Recall Inspection and Repair Instructions

NHTSA Recall #: 22V-814

Tiffin Motorhomes Recall #: TIF-127

Models Involved: 2023 Allegro Open Road, 2023 Allegro RED 340, 2022 and 2023 Allegro RED 360, 2022 and 2023 Allegro Breeze, 2022 and 2023 Allegro Bay, and 2022 and 2023 Phaeton Motorhomes, all equipped with the option for LP gas.

Figure 1 LPG tank style 4318

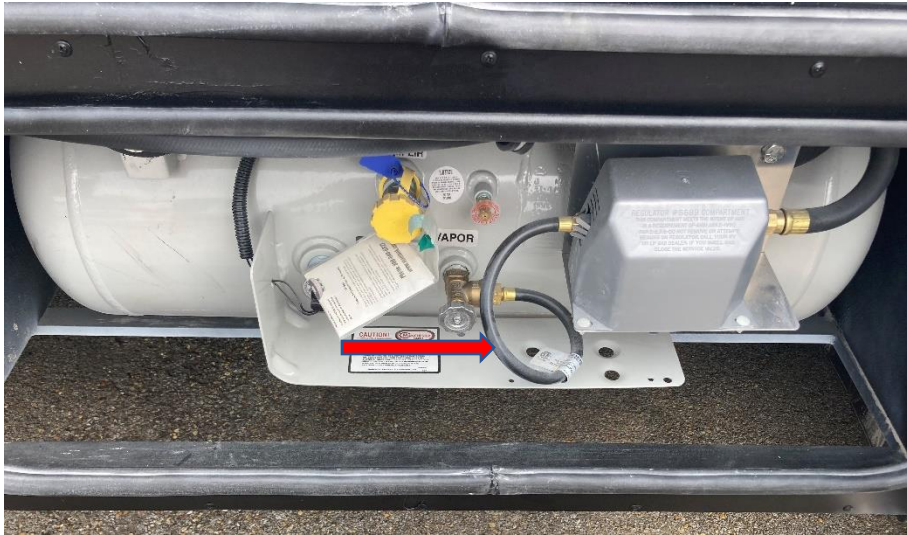
3. Figures 1, 2 and 3 have the LP hose marked with a red arrow.

Figure 4

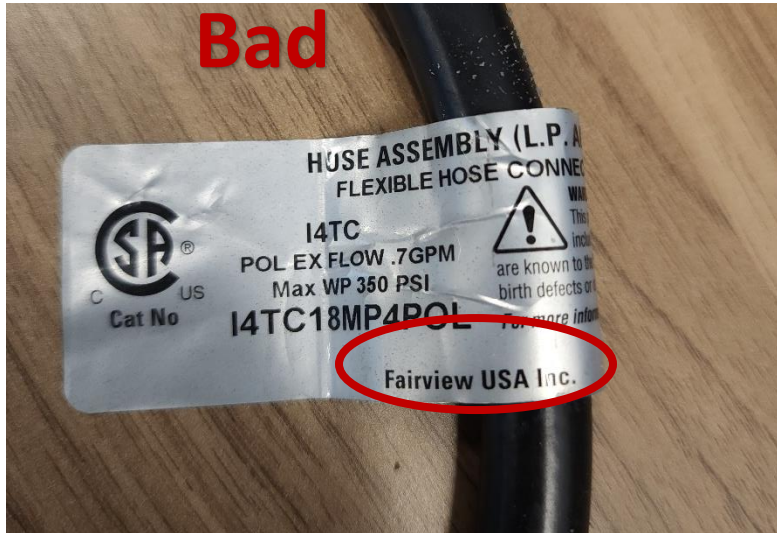
4. Identify which hose was originally installed on the unit to determine if the hose needs to be replaced. If the Marshall Excelsior hose with the white tag (Figure 4) is installed no further action is required.

Figure 5

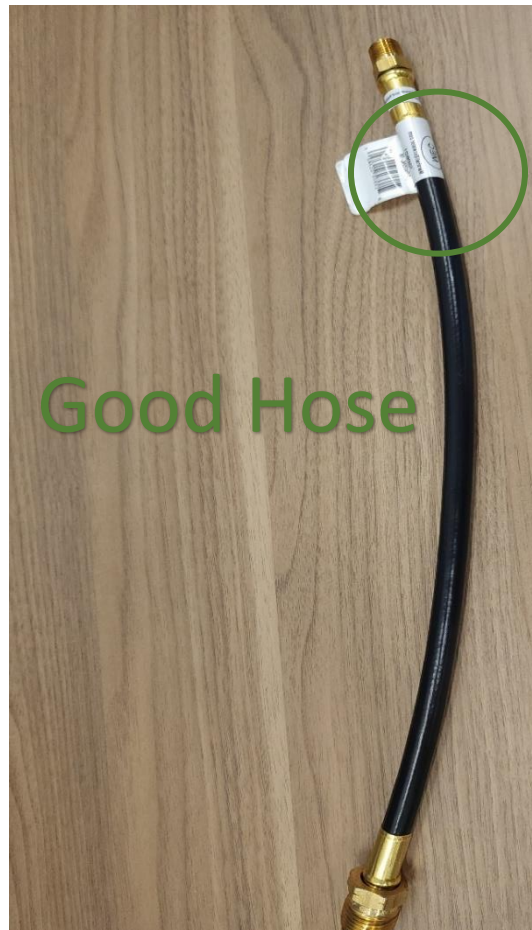
- 5. If the Fairview hose with the silver tag (Figure 5) is installed or there is no tag on the hose at all the hose will need to be changed out to the Marshall Excelsior with a white tag.

Figure 7

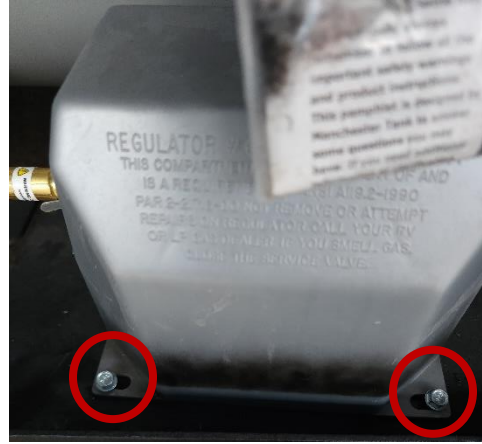
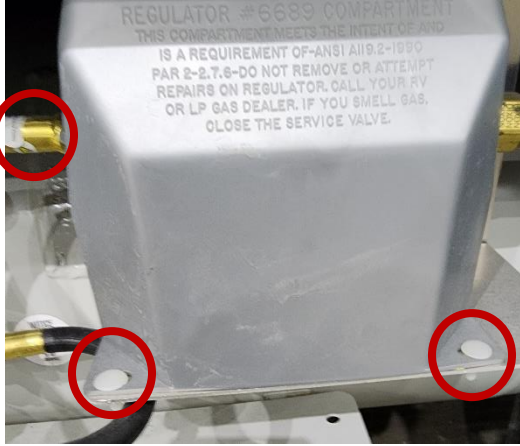
Secondary picture of the gas lines for reference (Figure 6 & Figure 7)
